Accredited Standards Committee*
X3, Information Technology

Doc. No.: X3T10/96-020 r1

To: X3T10 Membership
 Subject: Letter Ballot Results on forwarding SPC (96-012)

2. (E) 2nd page

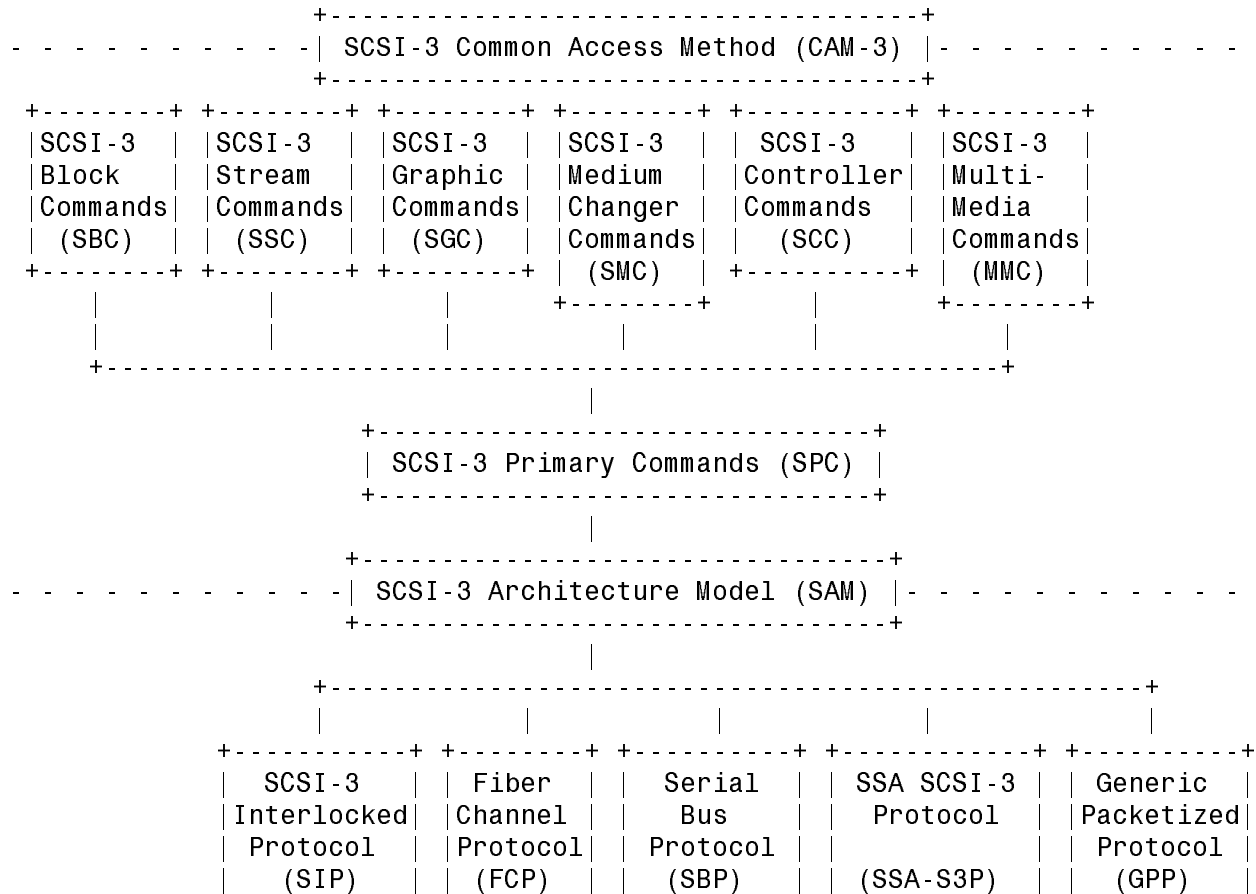
In the Patent Statement, "holder's" should be "holders".
